Access Compliance Report

Public Rights-of-Way

(Curb Ramps)

Intersection ID: 53380	Main Street: IKEA_BV	Cross Street: LEWIS_ST	Location: W
ADA ID: 624696D4FF2E	Ramp Type: Para	Initial Pass/Fail: Pass	Overall Compliance: No
		Severity Score: 7.5

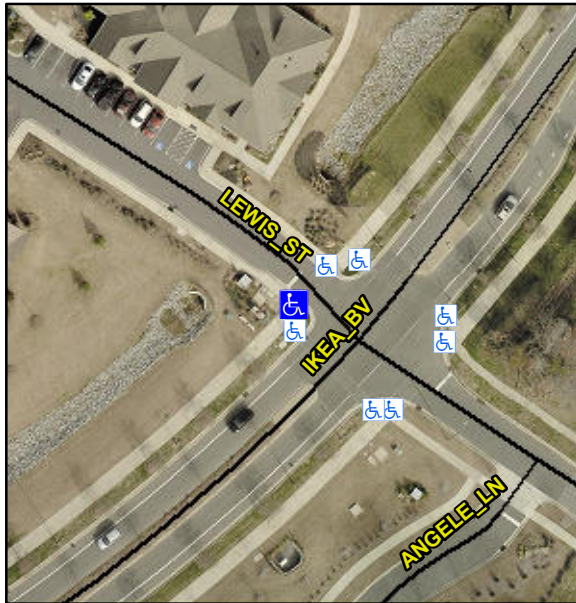
R302.7, R302.7.2, R304.5.3

Compliance	Description	Data	Compliance	Description	Data
N/A	Ramp Length LT (in)	N/A	N/A	Ramp Length RT (in)	153.0
N/A	Ramp Width LT (in)	N/A	Yes	Ramp Width RT (in)	59.0
N/A	Ramp Slope LT (%)	N/A	Yes	Ramp Slope RT (%)	7.5
N/A	Ramp XSlope LT (%)	N/A	Yes	Ramp XSlope RT (%)	0.8
Yes	Landing Length (in)	60.0	Yes	DWS Provided?	Yes
Yes	Landing Width (in)	96.0	Yes	DWS Contrast?	Yes
Yes	Landing Slope (%)	1.8	Yes	DWS Length (in)	24.0
Yes	Landing X Slope (%)	1.0	Yes	DWS Full Width?	Yes
N/A	Landing Curb? (Y/N)	Yes	Yes	DWS Offset (in)	1.5
N/A	Shared Landing?	No			
No	Gutter Ponding?	Yes	Yes	Gutter Slope (%)	2.8
No	Gutter Lip Ht (in)	0.5	No	Gutter X Slope (%)	2.2
N/A	Painted X Walk1?	Yes	N/A	Painted X Walk2?	N/A
	X Walk 1 Direction	To NE		X Walk 2 Direction	N/A
N/A	X Walk 1 Width (in)	95.0	N/A	X Walk 2 Width (in)	N/A
	X Walk 1 Slope (%)	2.9		X Walk 2 Slope (%)	N/A
	X Walk 1 X Slope (%)	1.7		X Walk 2 X Slope (%)	N/A
Yes	Ramp inside XWalk1?	Yes	N/A	Ramp inside XWalk2?	N/A

Road Slope (%)	N/A	N/A	Clear Space?	Yes
	Road X Slope (%)	N/A	N/A	Clear Space to XWalk (in)	N/A
Yes	Any Obstructions?	No	Yes	Storm Grate/Utility Hazard?	No
	Obstruction Type			Storm Grate/Utility Type	
		N/A			N/A
			Yes	Surface Condition? (G/P)	Good
			N/A	Curb Slope (%)	N/A

**Remove & Replace Entire Ramp.
Remove & Replace Gutter.**
